**ADDENDUM #3**

To: All Bidders  
Project Name: Renovations to:  
GVSD District Administration Office  
100 Lindenwood Drive, Malvern, PA 19355  
Prepared for: Great Valley School District  
301 Lindenwood Drive  
Malvern, PA 19355  
Date: January 13, 2023

Notice to all Contractors bidding the Renovations to the GVSD District Administration Office. This Addendum is to amend or clarify the Contract documents as follows:

**1 | FIRST FLOOR DIMENSION PLAN**  
 A110 SCALE: 1/8" = 1'-0"

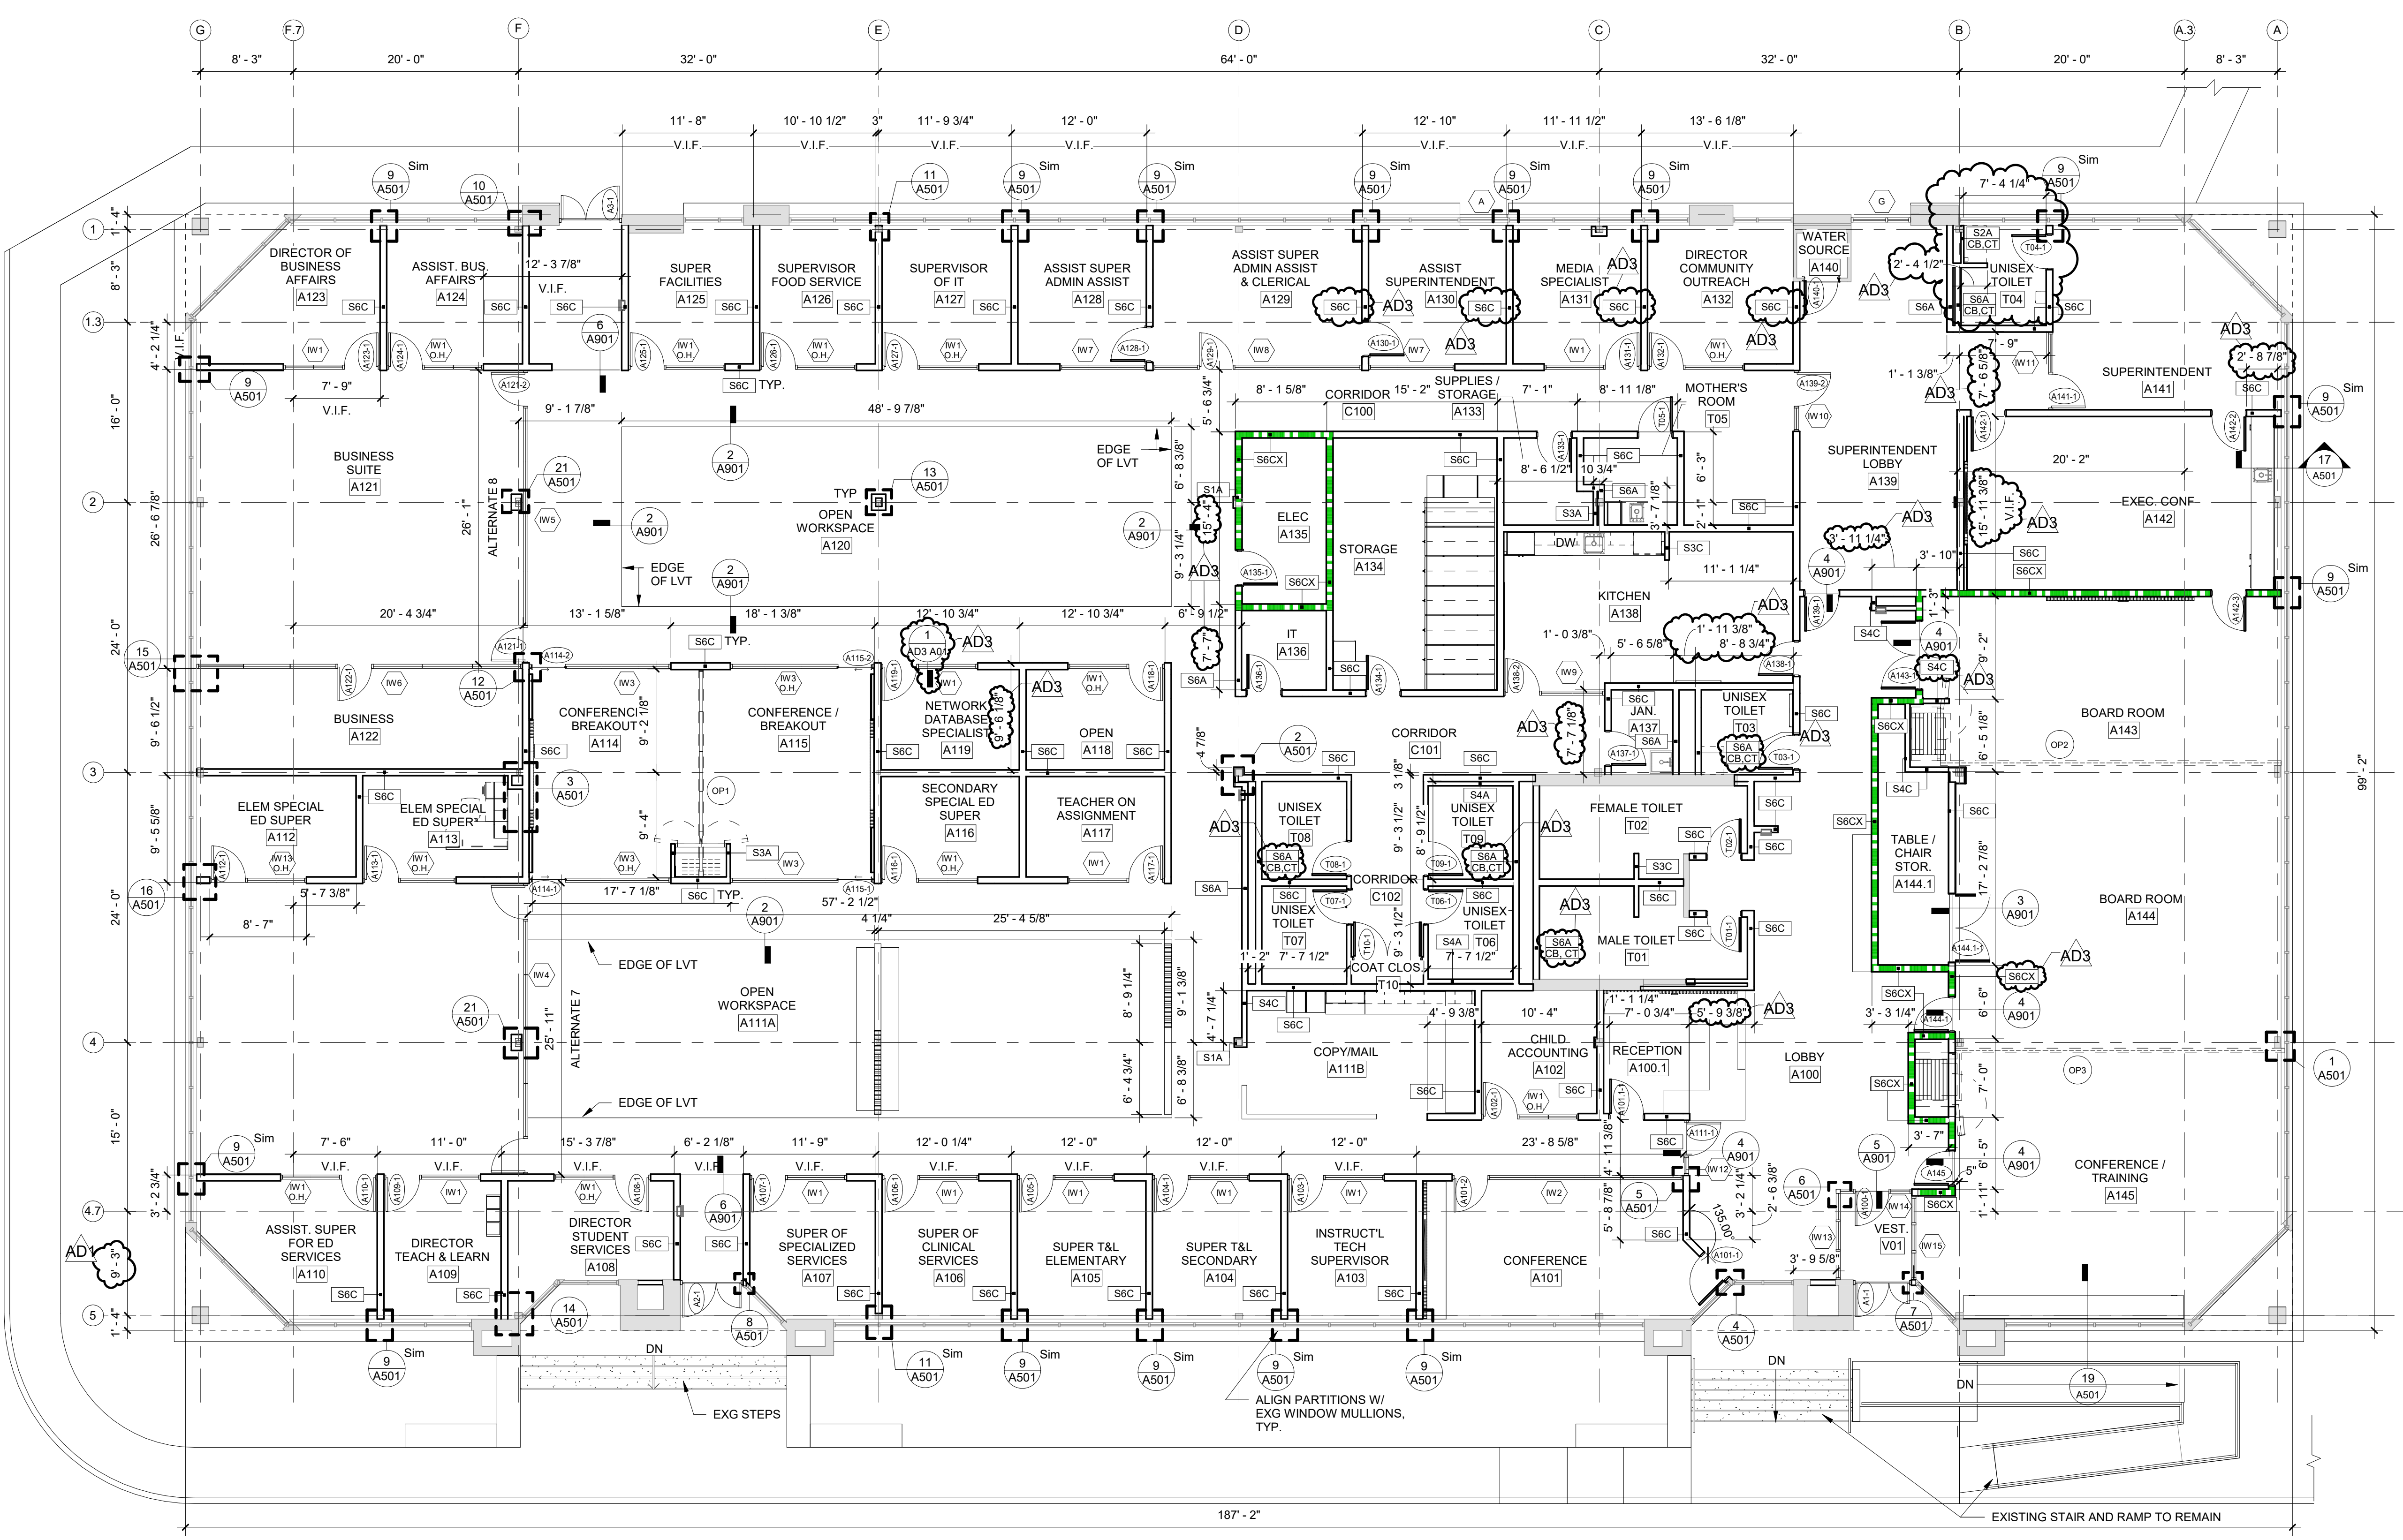
- 2.01 Drawing A110: **ADD** dimensions, wall type tags and wall detail tag as shown on attached drawing under this addendum.
- 2.02 Drawing A501: **ADD** details for Typical Jamb Profiles and Typical Fixed Panel Partition Wall Section as shown on sketch, AD3-A01.
- 2.03 Drawing A851: Detail 3, **MODIFY** note to read 12" CAST LETTER.

**Response:** *Anodized aluminum per Specification Section 102215 -Sliding/Fixed Glass Panel Partitions.*
- 3.012 **Question:** I was wondering if you could clarify something for me. On none of the partition types does it show where Cementitious backerboard goes for the bathrooms. The wall types are S6A S4A S4C but none of those show backerboard ON THE Partition type. Could you please clarify which walls get backerboard if not all of them. Thank you so much for your help.

**Response:** *See revised drawing A110 as part of this addendum. Cementitious backerboard should be provided behind ceramic tile in all wall applications.*

**1 FIRST FLOOR PLAN - POWER**  
E201 SCALE: 1/8" = 1'-0"

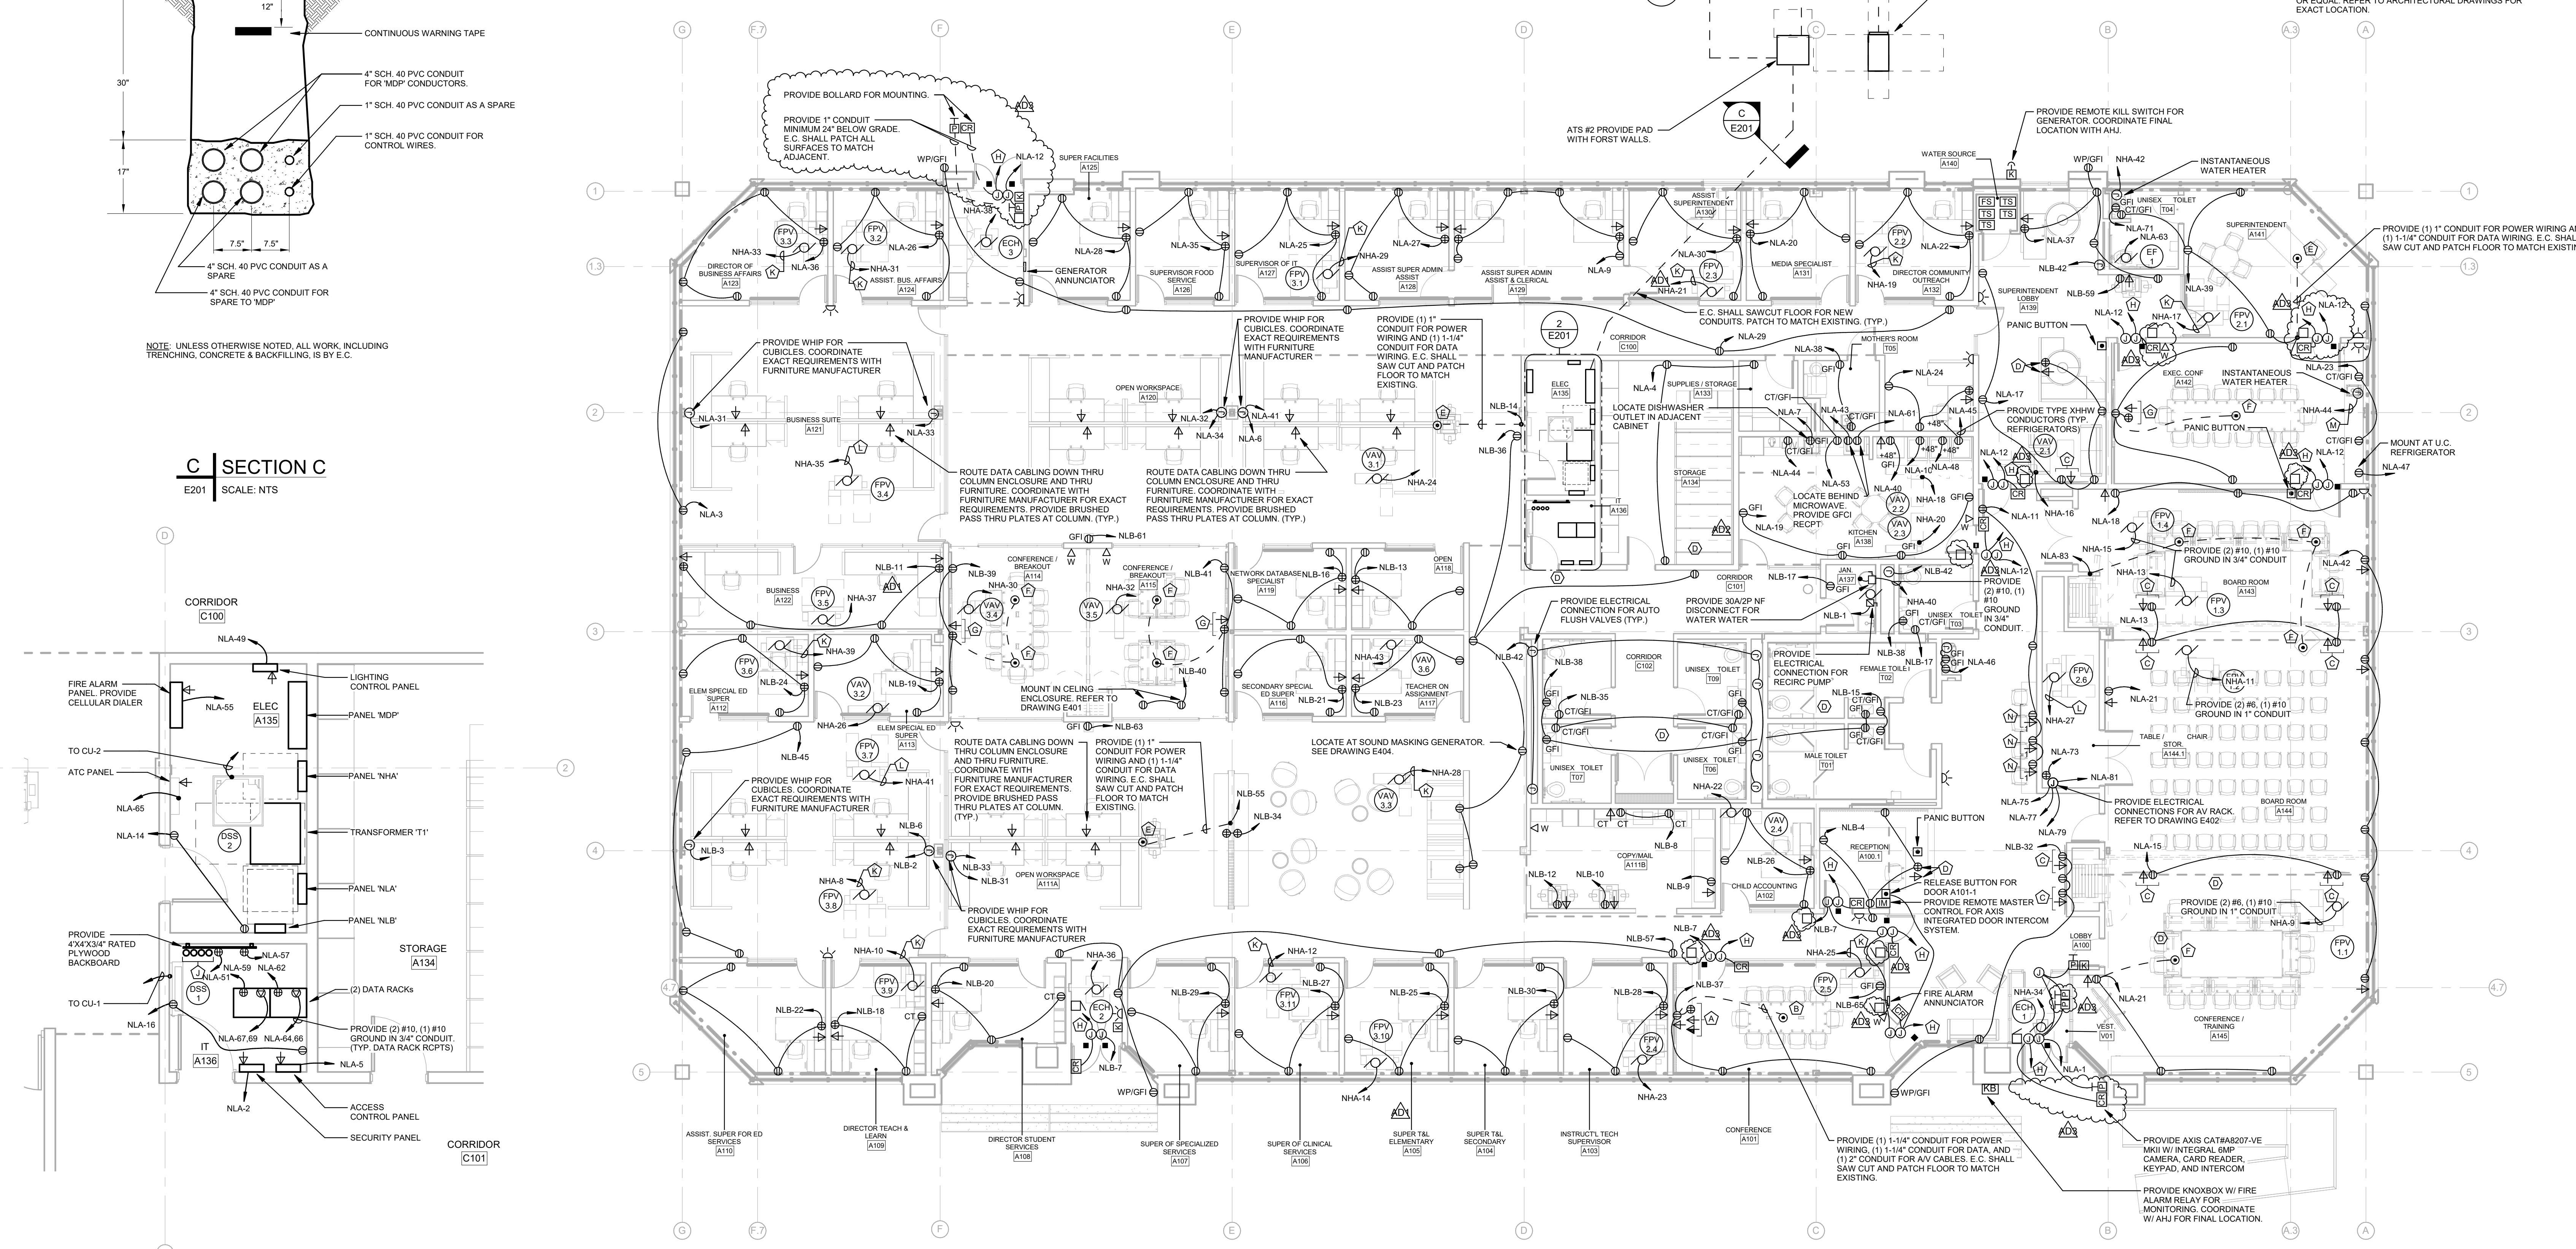
- 2.04 Drawing E201; **ADD** card reader between rooms A142 and A141 with reader on A142 side. Circuit to NLA-12. **REVISE** card reader at door between A139 and A142. Flip reader to other side of door. **RELOCATE** card reader and push plate at V01 to right side of entrance. **ADD** push plate in vestibule V01 to control entry door. **RELOCATE** card reader at exterior door near room A125 to right side of door. **ADD** push plate at exterior door near room A125 on both inside and outside. Mount exterior push plate on bollard. **ADD** alarm horn at all interior access doors on secure side.
